Tomago BESS – Traffic Management Plan Stage 1

Thank you for submitting the Traffic Management Plan Stage 1 in accordance with Condition, B8 Schedule 2 of the consent for the Tomago BESS (SSD-57107216). I also acknowledge your response to the Department's review comments and request for additional information.

Accordingly, as nominee of the Planning Secretary, I approve the revised Traffic Management Plan Stage 1 (Rev V3.3, December 2025).

Traffic Management Plan – Stage 1

Figure 4 Construction Vehicle Access and Egress

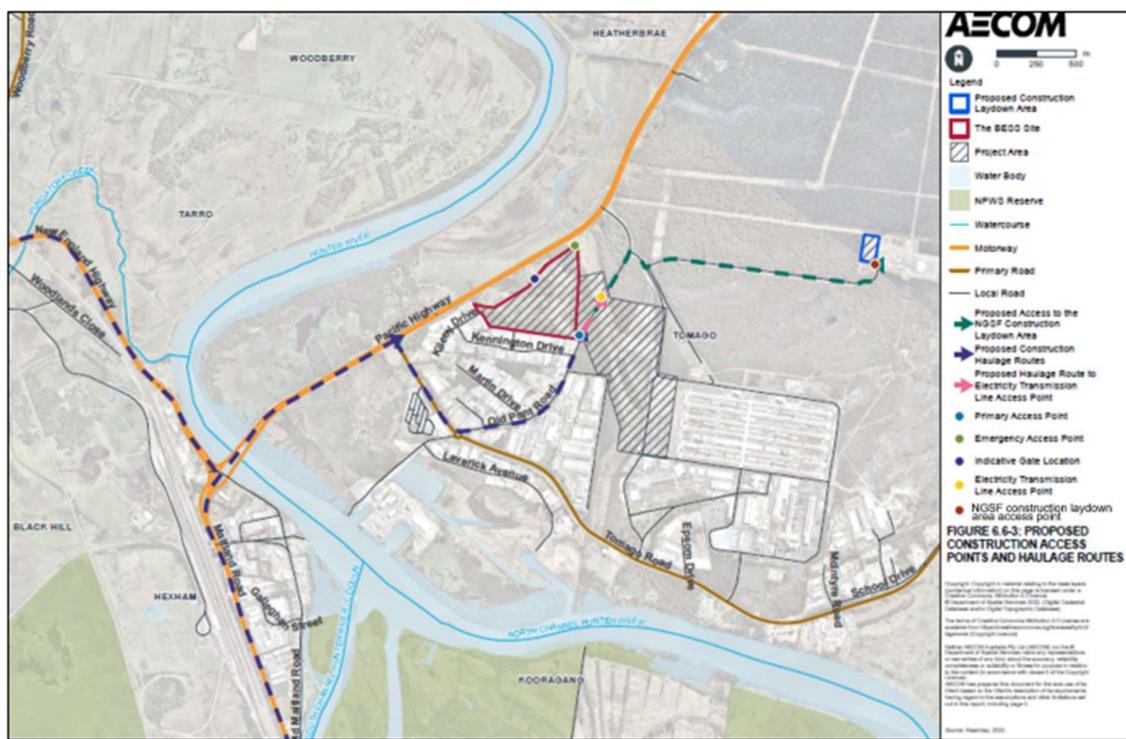
6.	B3. Unless the Planning Secretary agrees otherwise, all heavy vehicles and heavy vehicles requiring escort associated with the development must travel to and from the: (a) BESS site via the Pacific Highway, Tomago Road and Old Punt Road (vehicles exiting the site must turn left onto the Pacific Highway only);	Partial	Section 3.4.1.1 Heavy Vehicle Access address sub condition B3(a). Section 3.4.3 provides a general overview of the route to be used by construction vehicles. Figure 3 shows this route however the scale of the map provides little detail.	Please include the Figure in Appendix 4 of the consent to more clearly show vehicle access points and routes into and out of the site.	Updated – Figure 4	Figure 4 is not consistent with Appendix 4 of the consent. The Figure in the TMP illustrates inbound and outbound route. Include a commitment with Figure consistent with condition B3 and Appendix 4.	Replaced Figure 4 with Appendix 4.
